STAFF RECOMMENDATION
217 South 10th Street
May 16, 2012

Application: New Construction—addition; Setback reduction.

Description of Project: Application is to construct a second detached modular classroom. The project requires a reduction to the side setback.

217 S. 10th Street: Liberty Collegiate Academy: Modular Phase Two
HISTORIC ZONING COMMISSION APPLICATION FOR CERTIFICATE OF APPROPRIATENESS
May 2nd, 2012

ELEVATION FROM FATHERLAND STREET

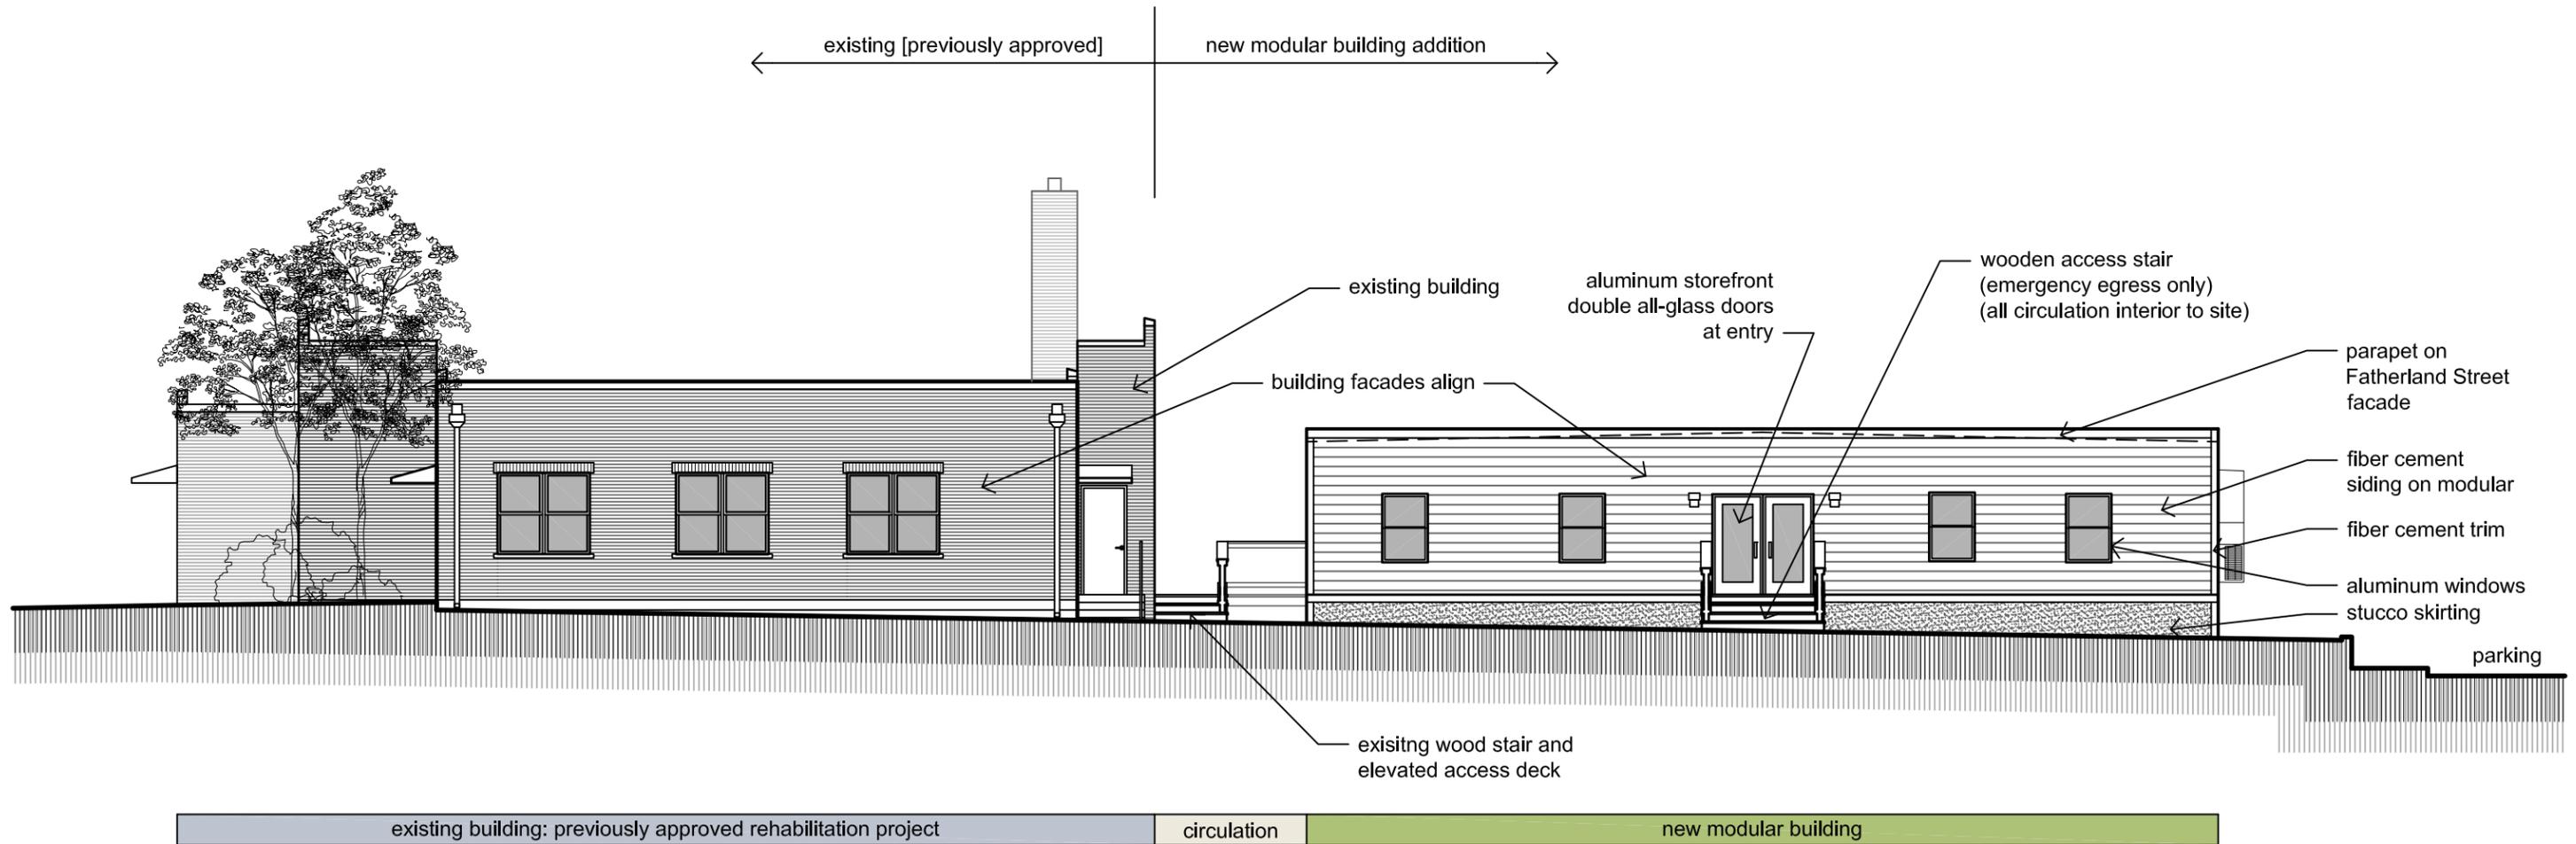
Roof: The existing structure has a flat roof with a stepped parapet wall on the front and rear facades. The new modular structure's roof will largely be flat, although on the Fatherland Street/south façade, there will be a slightly pedimented parapet with a slope of ¼ - 12. Staff finds the modular structure's flat roof and parapet to be appropriate because this structure is utilitarian in nature and because portions of the historic structure have a flat roof. Staff therefore finds the addition's roof form to meet Sections II.B.5. and II.B.10. of the *Lockeland Springs-East End Neighborhood Conservation Zoning Overlay: Handbook and Design Guidelines*.

Materials, Texture, and Details and Material Color: The proposed modular structure will be clad in smooth fiber cement siding with a seven and one-quarter inch (7 1/4") reveal. This is more than the maximum five inch (5") reveal typically required; however, the five inch (5") reveal is not available for this pre-manufactured temporary structure. The base of the structure will be stucco panels to mimic a foundation line. The windows will be aluminum and will be painted white. The doors that face Fatherland Street will be aluminum and full-glass storefront doors. Wooden stairs will be constructed at the Fatherland street entrance. The primary entrance to the structure will be on the west elevation (facing the back of the historic structure); those doors will only be minimally visible and will be metal.

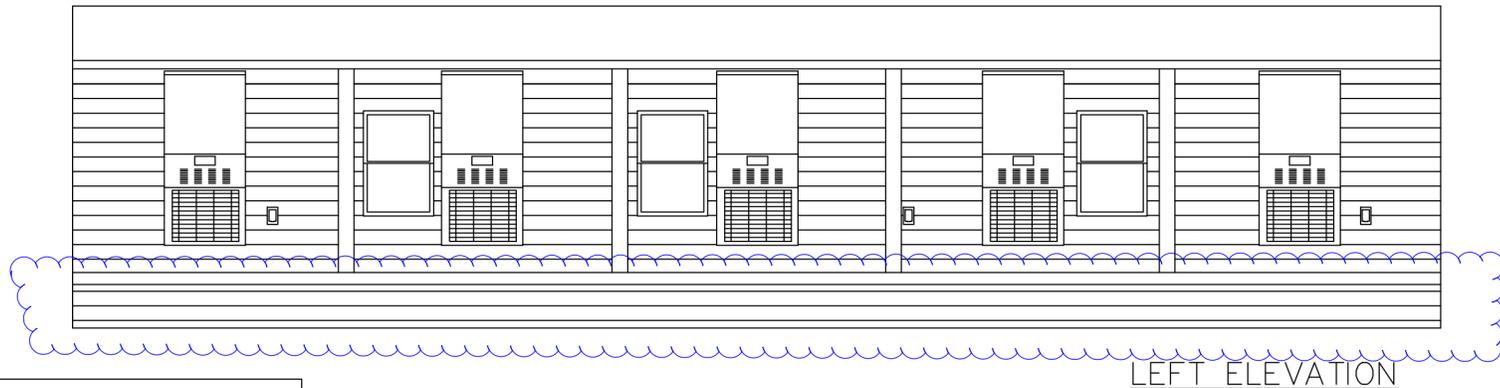
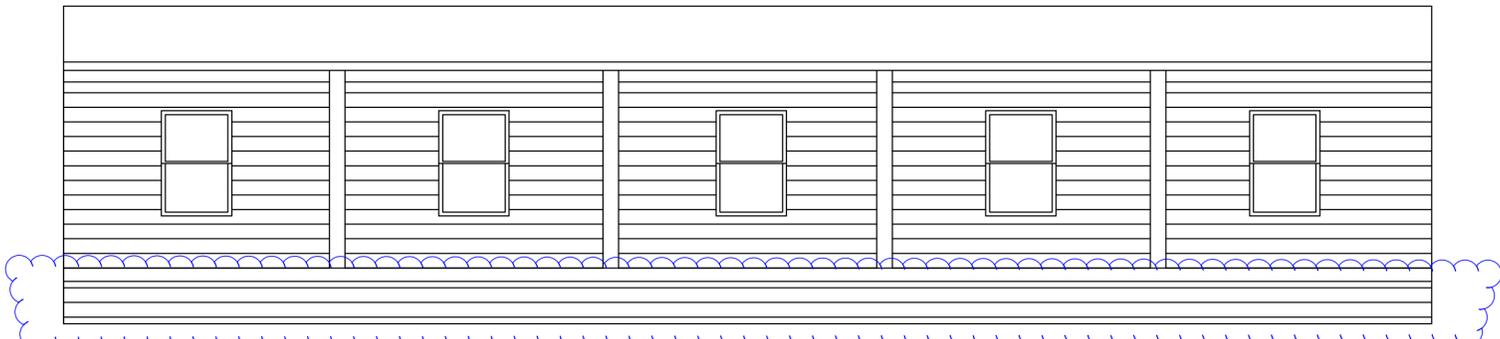
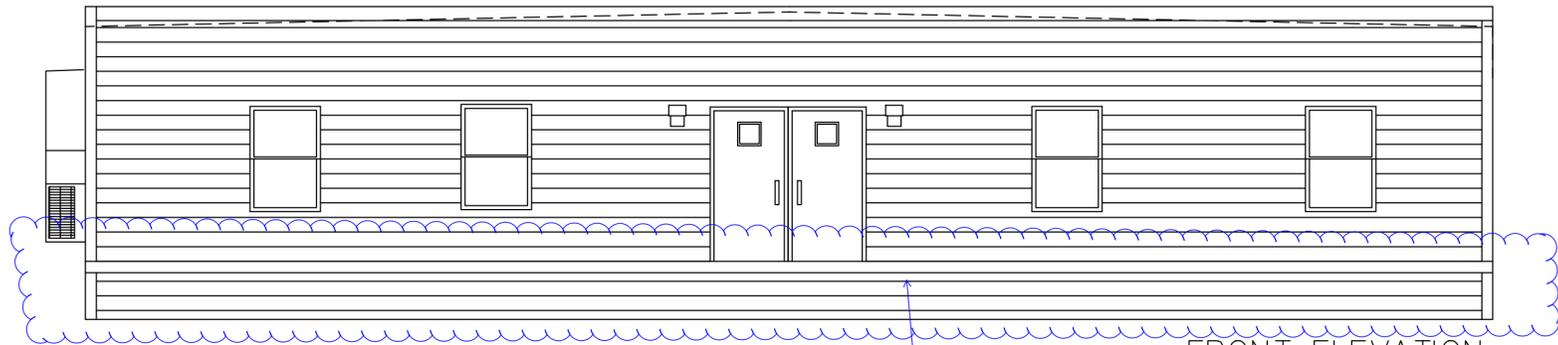
Base modified to stucco.

Entry doors changed to aluminum storefront with all glass.

REAR ELEVATION

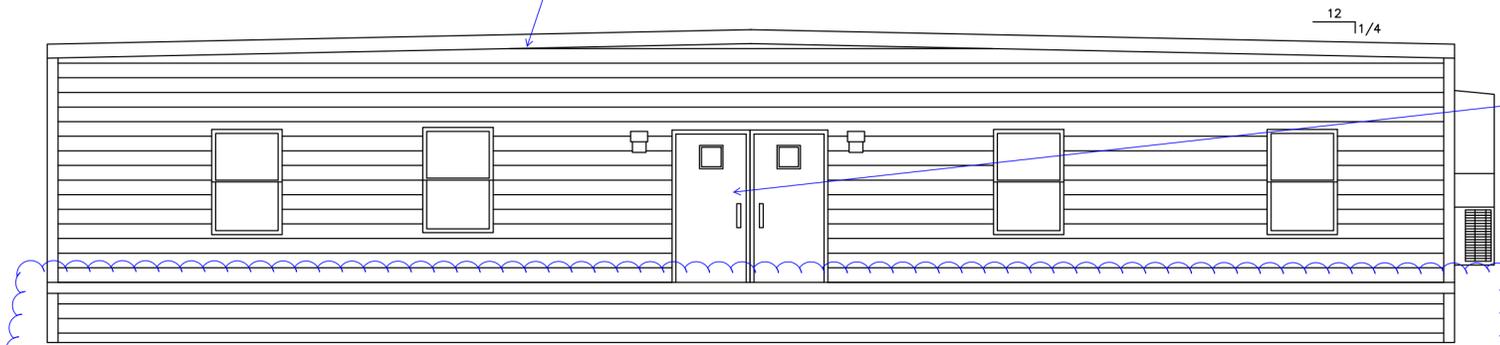
Parapet on this elevation - not on 'Front'. This elevation faces Fatherland.
